18 June 2021

Re: DEVELOPMENT APPLICATION NO. DA/642/2020 – 11-19 FRENCHMANS ROAD, RANDWICK
APPLICANT'S RESPONSES TO COUNCIL REQUEST FOR INFORMATION AND DESIGN
EXCELLENCE PANEL COMMENTS
AMENDED DEVELOPMENT APPLICATION AND ADDENDUM STATEMENT OF ENVIRONMENTAL
EFFECTS

Table 1: List of Amended Documents and Appendices References

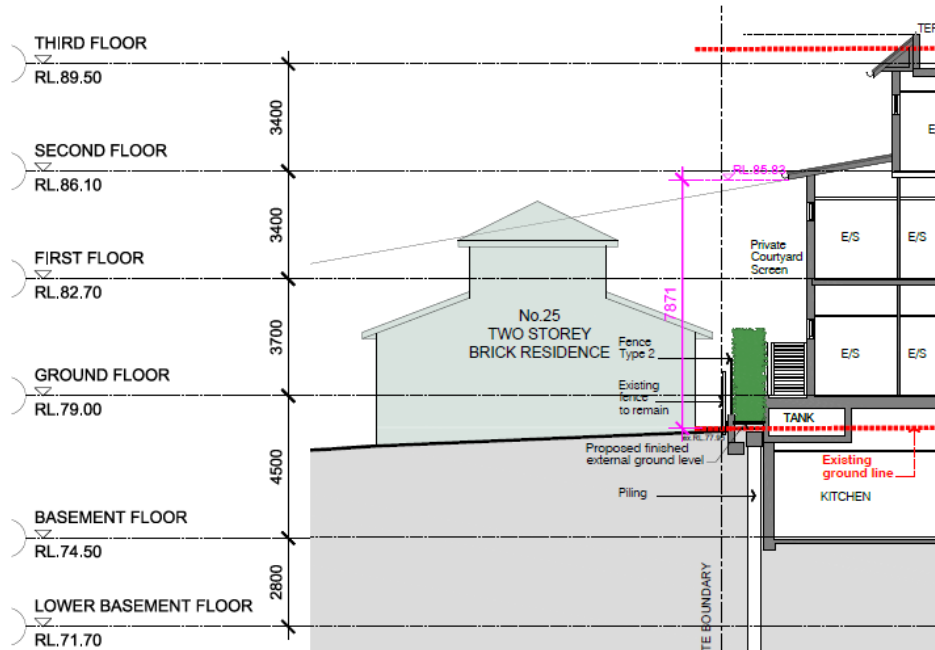
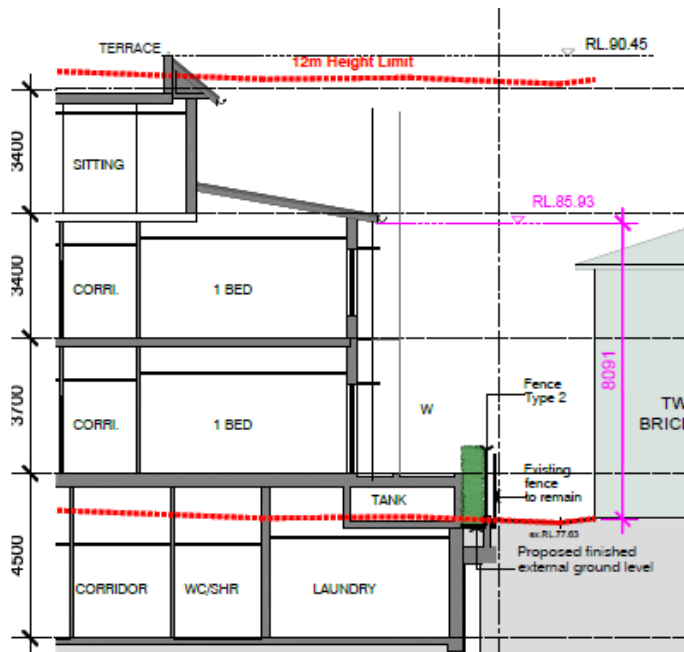
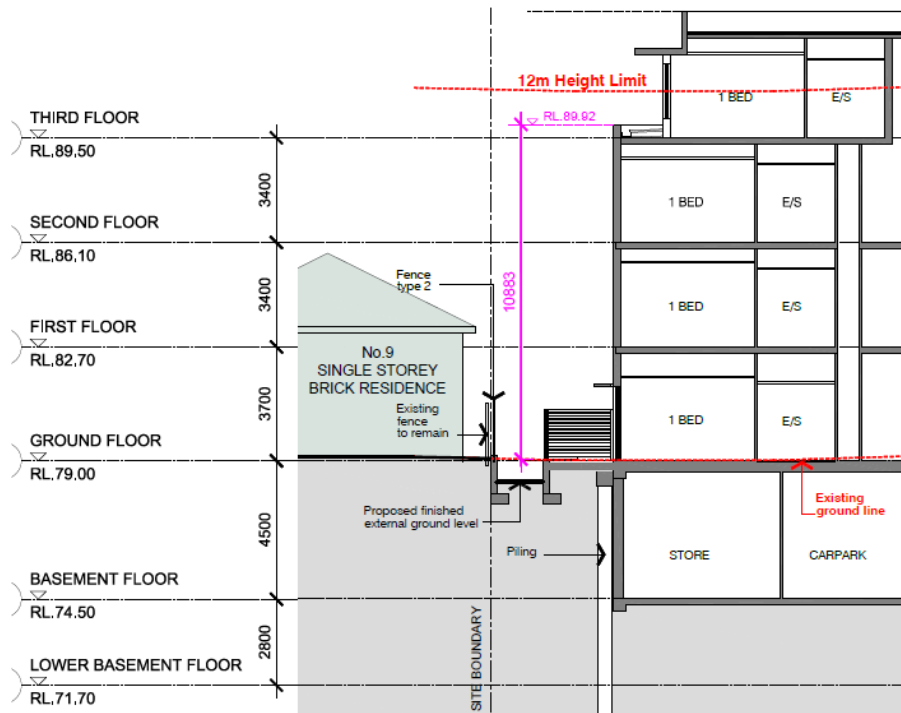
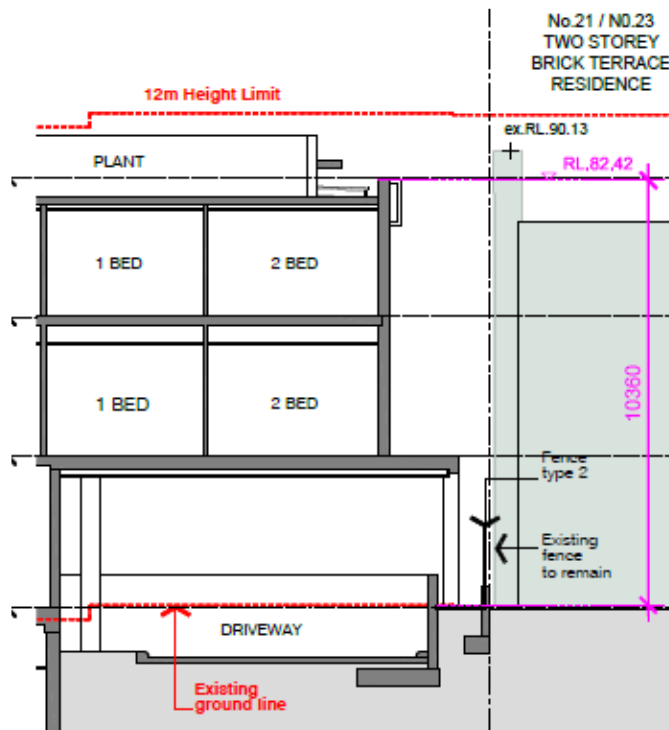
RANDWICK DEP COMMENTS	APPLICANT RESPONSE
	<p>understand the wall height at the boundaries of the site. Based on this drawing and the summary above, the proposal has been amended so as the wall height complies with the exception of Section K at the western boundary to 9 Frenchmans Road which involves a 33cm variation or 3% variation of this DCP control. The applicant requests Council support the minor variation on this occasion as the proposal remains consistent with the intent of the wall height and does not result in excessive bulk in that location, unacceptable overshadowing and the elevation has been designed so as to avoid loss of privacy or overlooking into 9 Frenchmans Road.</p> <p>The Urban Design peer review completed by Matthew Pullinger included in Appendix G, advises in part:</p> <p><i>“Frenchmans Road Building Articulation and Elevational Composition</i></p> <p><i>In response to the Panel’s concerns for the architectural composition and expression along Frenchmans Road, a number of amendments have been made.</i></p> <p><i>The building form has been more strongly articulated into three related elements. This is evident in the various 3D streetscape views created at the pedestrian’s eye level looking east or west along Frenchmans Road. This strong articulation has the effect of foregrounding three elements within the streetscape.</i></p> <p><i>Each of these elements is of a more modest scale, and familiar to the buildings elsewhere in the immediate vicinity. The indented elements that separate these three elements are recessive and calmly detailed.</i></p> <p><i>The foregrounded elements now adopt a more contemporary architectural expression that combines more composed proportions and introduces greater depth into the facade.</i></p> <p><i>These design amendments have the effect of tying the amended proposal more closely to positive cues elsewhere in the streetscape.</i></p> <p><i>The proposed roof forms have been amended to revert to a simpler language of parapets - coinciding with the foregrounded elements - and</i></p>

- The wall heights to each boundary have been reduced and amended as detailed in new architectural drawing DA13a as included in **Appendix C** and discussed in detail previously in this Addendum SEE above and Table 5.

7	<p>DA05 Ground Floor Plan</p>  <p>Setbacks to 21 Frenchmans Road: 570mm, 1030mm and 10350mm</p>	<p>DA05 Ground Floor Plan Rev B dated 1 June 2021</p>

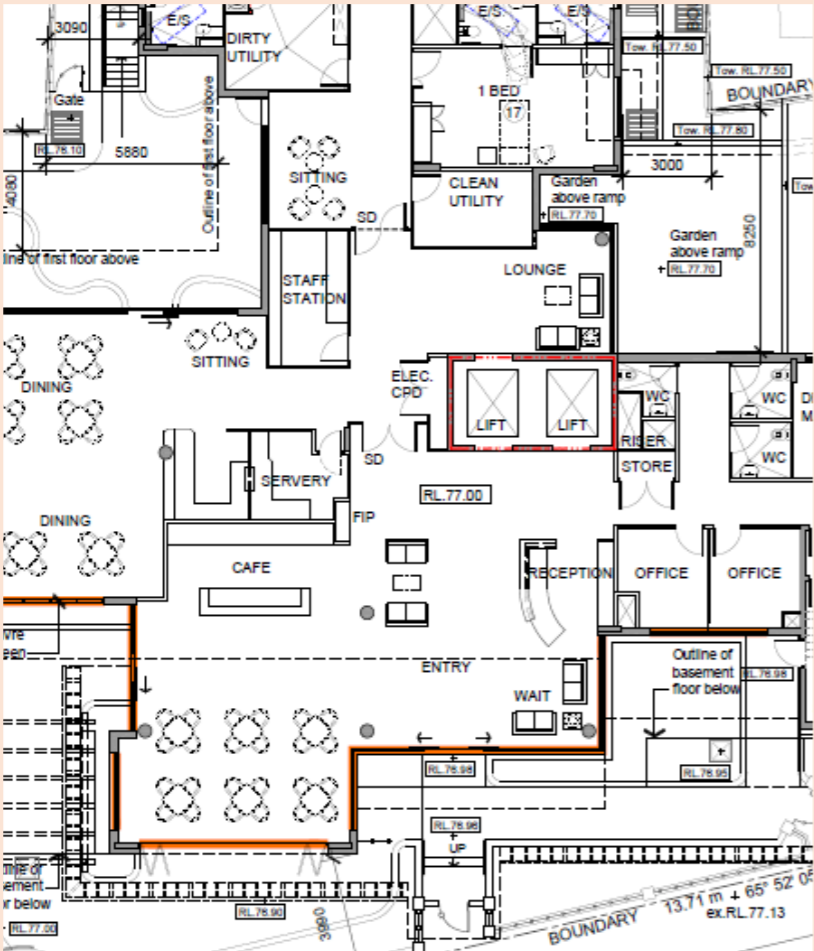
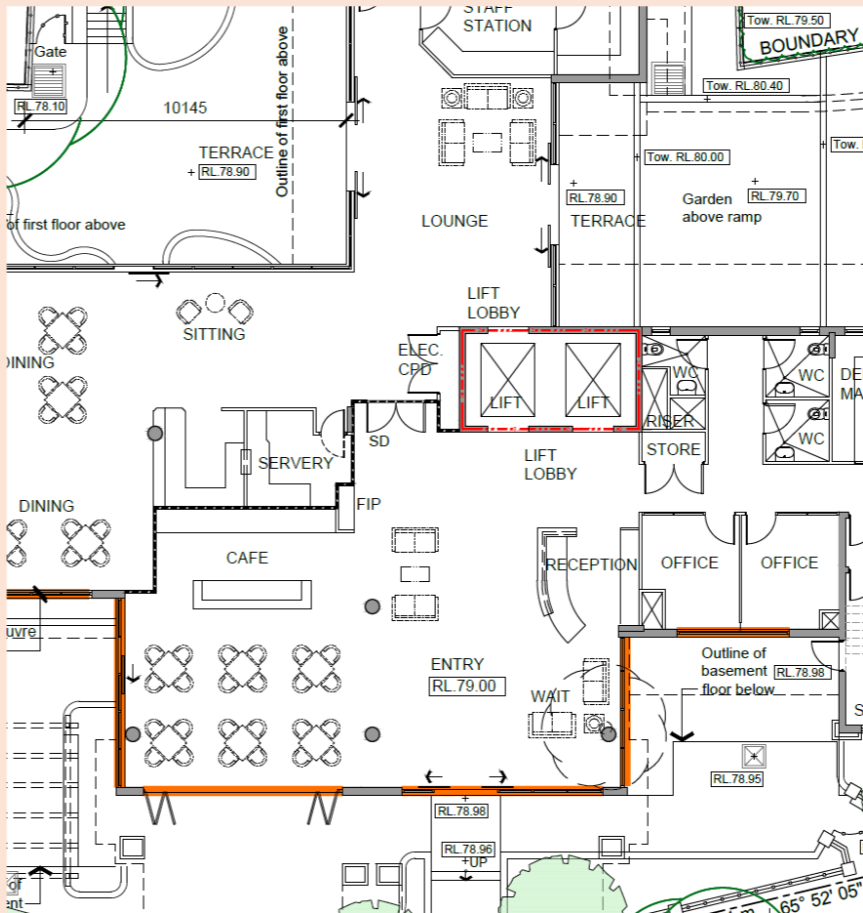
R O W	Original Architectural Design	Amended Architectural Design
	<p>Setback to McLennan Avenue boundary (northern): between 2690mm and 2750mm</p> <p>Setbacks to 25 McLennan Avenue boundary: between 2540mm, 2740mm, 3000mm and 3610mm</p> <p>Setbacks to 27 McLennan Avenue boundary: 2510mm, 3090mm, 3570mm and 6030mm</p>  <p>Setbacks to 23 McLennan Avenue boundary: 10665mm</p> <p>Setbacks to 29 McLennan Avenue boundary: 2510mm</p> <p>Setbacks to 8 Astolat Street boundary: 2375mm</p> <p>Setbacks to 9 Frenchmans Road: 4000mm</p>	<p>Setbacks to 21 Frenchmans Road: no change 570mm, 1030mm and 10350mm - Trellis system over driveway ramp – refer also to amended landscape architectural drawings</p> <p>Setback to McLennan Avenue boundary (northern): no change between 2690mm and 2750mm</p> <p>Setbacks to 25 McLennan Avenue boundary: no change between 2540mm, 2740mm, 3000mm and 3610mm</p> <p>Setbacks to 27 McLennan Avenue boundary: 2510mm, 3090mm, 3570mm and 10140mm enlarged outdoor western terrace with removal of room, reduction in size of utility room; repositioning of staff station; increased glazing windows with inclusion of new doors to create connection between western terrace and eastern terrace via internal lounge area.</p>  <p>Setbacks to 23 McLennan Avenue boundary: 10665mm</p> <p>Setbacks to 29 McLennan Avenue boundary: 2510mm</p> <p>Setbacks to 8 Astolat Street boundary: 2375mm</p> <p>Setbacks to 9 Frenchmans Road: 4000mm</p>

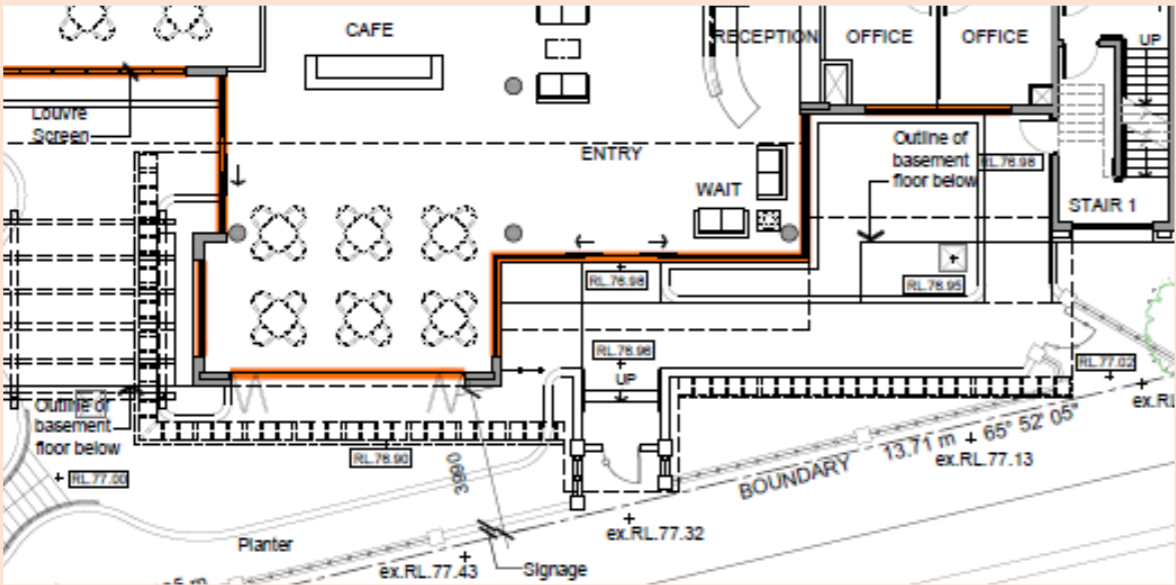
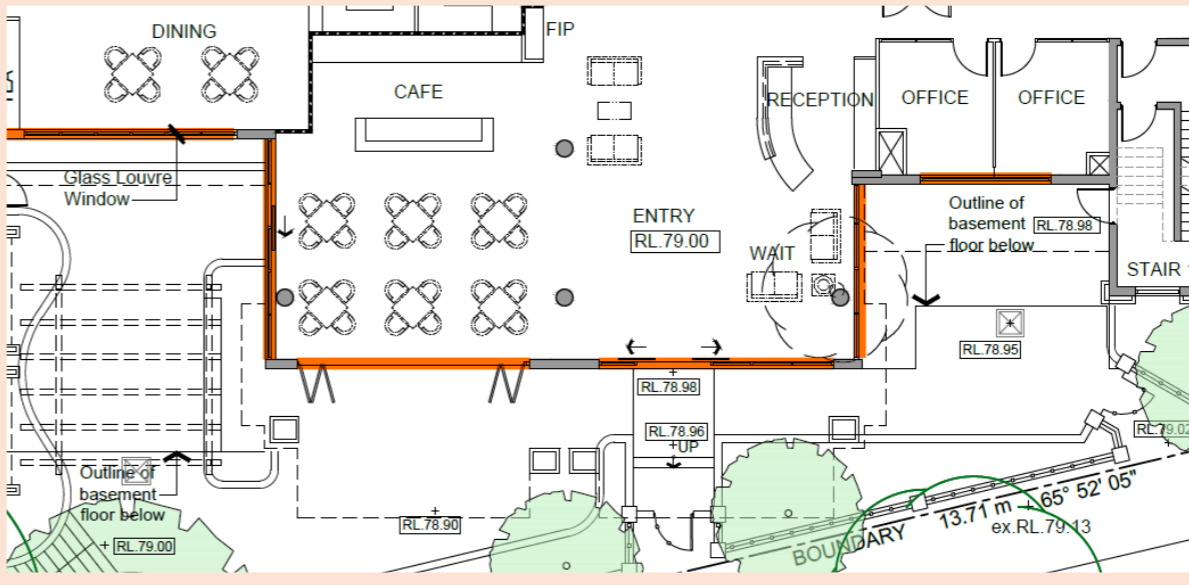
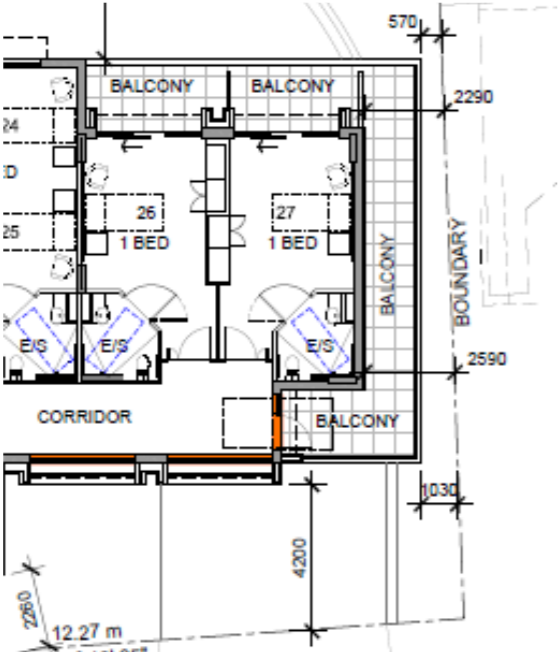
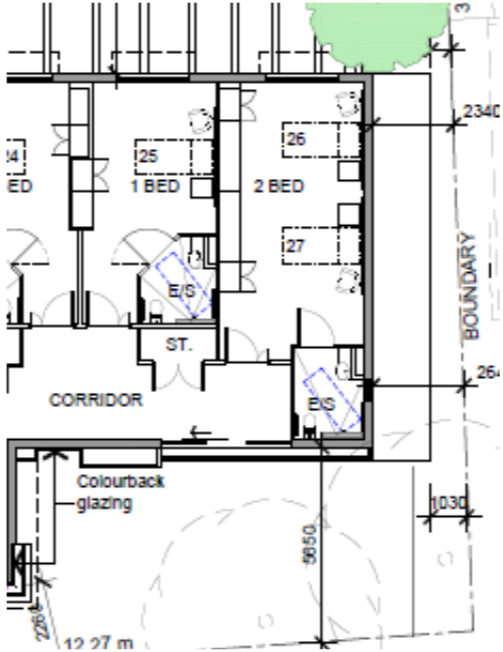
Setbacks to Frenchmans Road: 2260mm, 3990mm, 5855mm and 7405mm		Setbacks to Frenchmans Road: 2260mm, 4000mm – 7500mm, 5855mm and 7405mm - increased setback to Frenchmans Road at entrance with reduced lounge area and creation of covered verandah.	
8	<p>DA06 First Floor Plan</p> 		<p>DA06 First Floor Plan Rev B dated 1 June 2021:</p> 	
	Setbacks to 21 Frenchmans Road eastern boundary: between 570mm, 1030mm, 2290mm and 2590mm Setback to McLennan Avenue boundary (northern): between 1845mm, 2690mm and 2750mm		Setbacks to 21 Frenchmans Road eastern boundary: 570mm, 1030mm, slight increase 2340mm and 2640mm - removal of balconies on eastern first floor level and removed to rooms 26 and 27 Setback to McLennan Avenue boundary (northern): increase between 2645mm, 2750mm and 2890mm – Juliet balcony deleted awning screen inserted

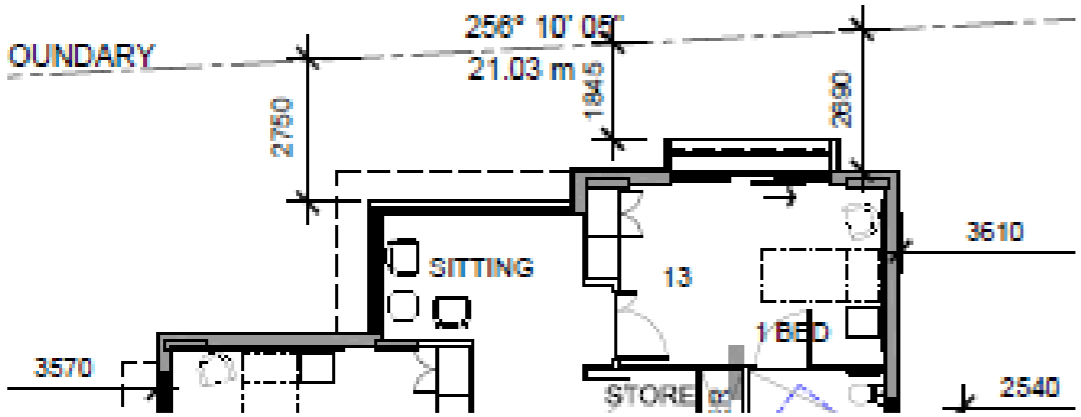
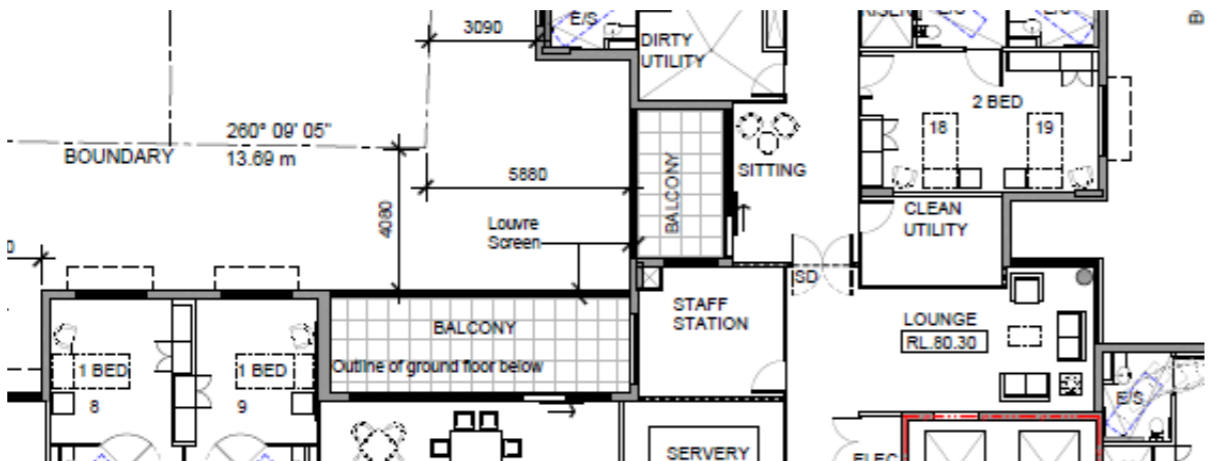
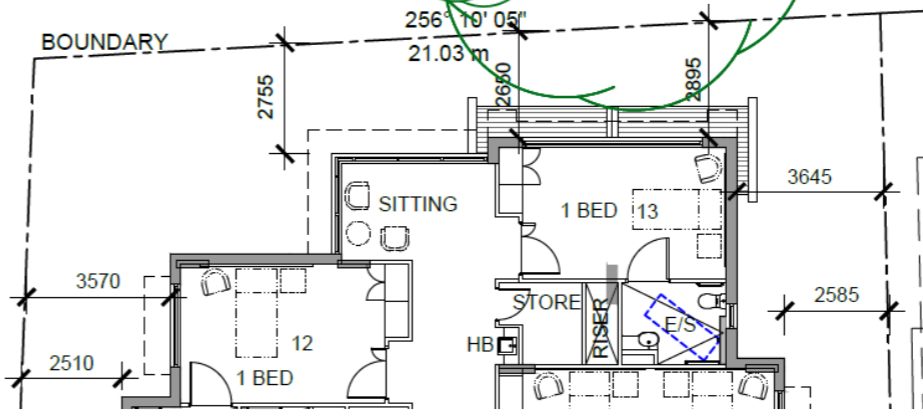
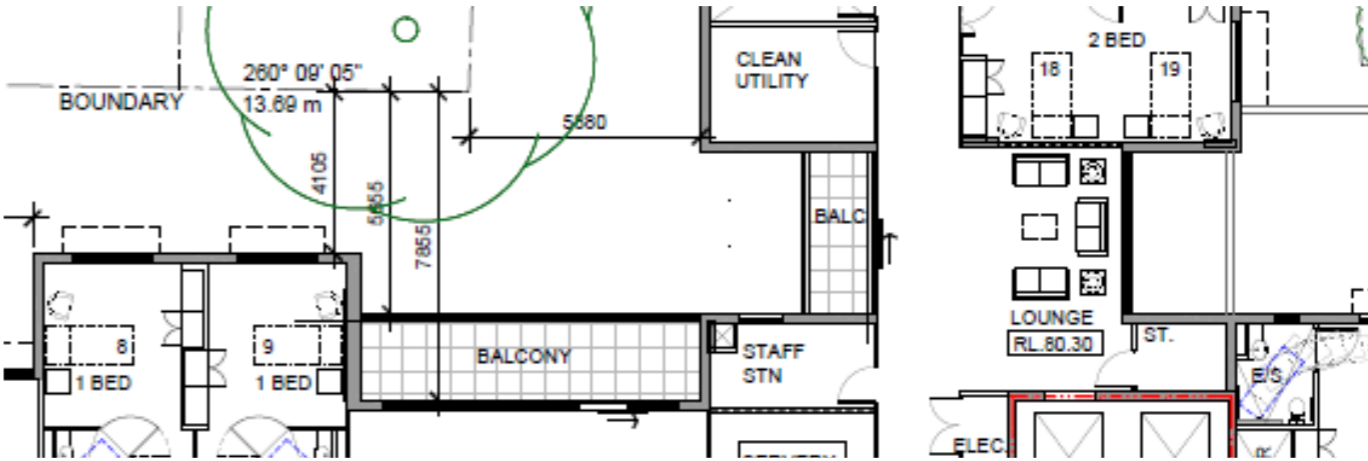
<div> <div>R O W</div> <div>Original Architectural Design</div> </div>	<div> <div>Amended Architectural Design</div> </div>
 <p>Setbacks to 25 McLennan Avenue boundary: eastern between 2540mm, 2710mm and 3610mm and northern boundary 6330mm</p> <p>Setbacks to 27 McLennan Avenue boundary (western boundary): between 2510mm, 3090mm, 3570mm, and 5880mm</p>  <p>Setbacks to 27 McLennan Avenue boundary (northern boundary): between 4080mm and 6080mm</p> <p>Setbacks to 23 McLennan Avenue boundary: 8660mm</p> <p>Setbacks to 29 McLennan Avenue boundary: 4080mm</p> <p>Setbacks to 8 Astolat Street boundary: western boundary 2600mm and northern boundary 2375mm</p> <p>Setbacks to 9 Frenchmans Road: 4000mm</p> <p>Setbacks to Frenchmans Road: between 2175mm, 2260mm, 3500mm, 3990mm, 4200mm, 5230mm, 5855mm, 6600mm, 7190mm and 7405mm</p>	 <p>Setbacks to 25 McLennan Avenue boundary: increased eastern between 2575mm, 2745mm and 3645mm and northern 6335mm</p> <p>Setbacks to 27 McLennan Avenue boundary (western boundary): increased between 2510mm, 3090mm, 3570mm, 5880mm and 10140mm</p>  <p>Setbacks to 27 McLennan Avenue boundary (northern boundary): slight increase between 4105mm, 5555mm and 7855mm</p> <p>Setbacks to 23 McLennan Avenue boundary: no change 8660mm</p> <p>Setbacks to 29 McLennan Avenue boundary: slight increase 4105mm</p> <p>Setbacks to 8 Astolat Street boundary: no change western boundary 2600mm and northern boundary 2375mm</p> <p>Setbacks to 9 Frenchmans Road: no change 4000mm</p> <p>Setbacks to Frenchmans Road: increased 2260mm, 5650mm, 5835mm, 5855mm, 7190mm and 7405mm</p>
